MIL-C-5809G
AMENDMENT 1
23 September 1992

MILITARY SPECIFICATION

CIRCUIT BREAKERS, TRIP-FREE, AIRCRAFT,
GENERAL SPECIFICATION FOR

This amendment forms a part of MIL-C-5809G, dated 30 November 1987, and is approved for use by all Departments and Agencies of the Department of Defense.

FIGURE 2a. Sample fixture.

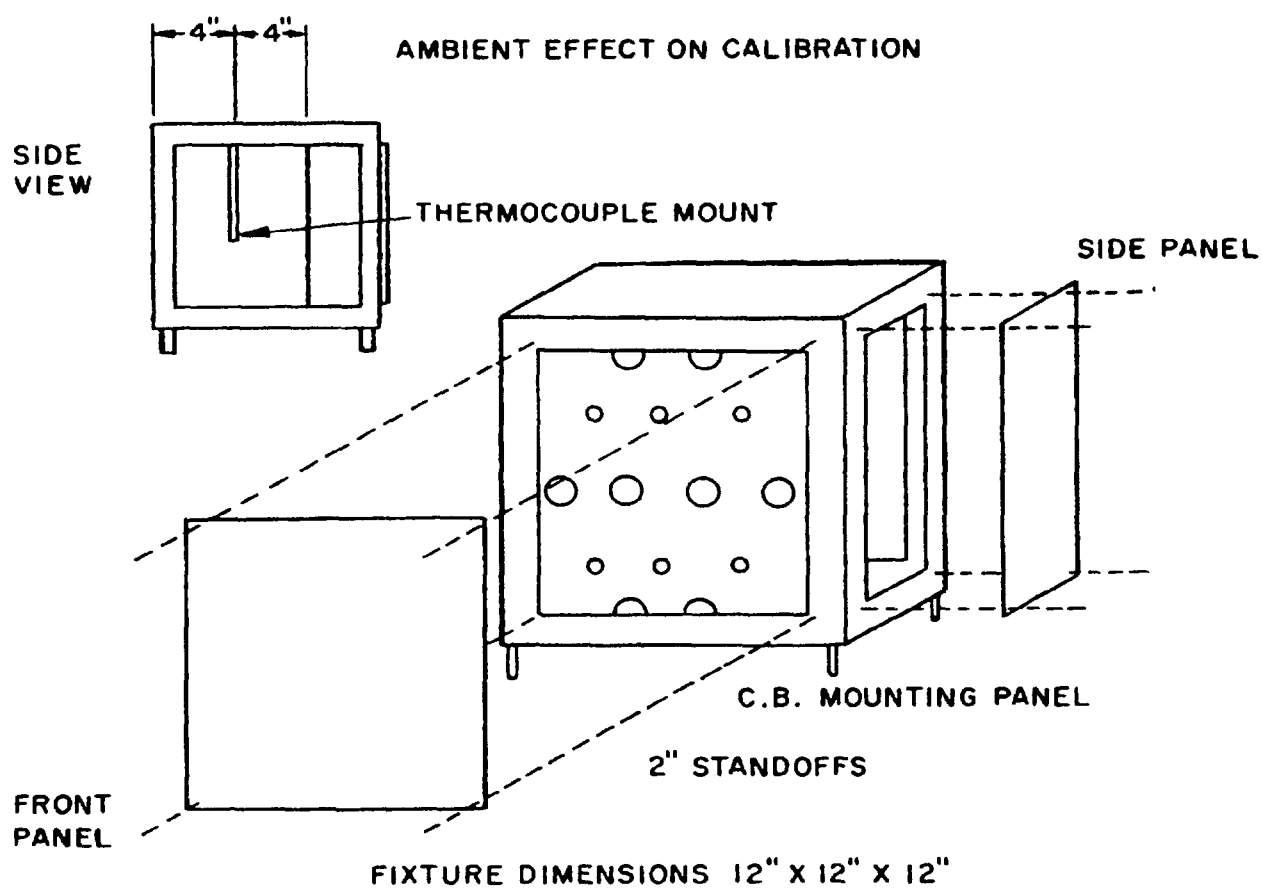
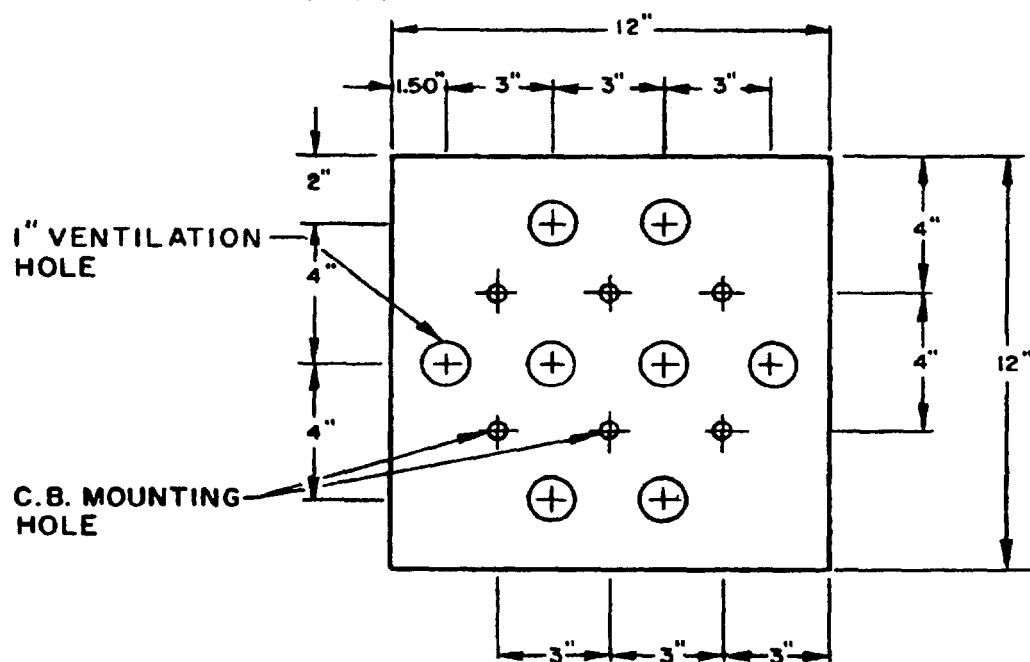
After 4.7.7.5.1, insert the attached figures 2a through 2d.

"4.7.7.5.1 Still air environment. Still air environment is the area surrounding the circuit breakers within a given chamber where any reduction in air velocity within the area of the circuit breakers would cause a maximum 2°C rise in temperature. The still air environment for temperature chambers 4 cubic feet and larger shall be obtained by using the fixture shown on figure 2a. Fixture dimensions are shown on figures 2b and 2c. The test fixture shall be placed in the temperature chamber so that the rear lead port of the fixture is facing away from the direct air flow created by the chamber circulating fan. A typical installation is shown on figure 2d. The distance of the rear lead port from the chamber wall shall be determined by first placing a fully loaded fixture beginning at 1 inch from the chamber wall and performing the minimum limit of ultimate trip test at both extremes of temperature. The temperature rise inside the fixture shall be monitored during the test. If the internal temperature exceeds the 2°C limit, the test shall be stopped and the fixture moved away from the chamber wall in small increments until the fixture internal temperature maintains the temperature gradient of +2°C within the area of the circuit breakers. During the performance of all calibration tests, a minimum of 18 inches of lead length shall be kept inside the chamber to cancel any of the effects of heat conduction from the circuit breakers through the leads. Room ambient tests shall be performed inside a temperature chamber set at 25°C. Alternate means of obtaining the still air environment must be approved by the Qualifying Activity.

For chambers that are less than 4 cubic feet in volume, the fixture dimensions stated for the chambers that are 4 cubic feet and larger can be modified and the number of circuit breakers that can be tested at one time can be reduced in order to meet the still air requirements."
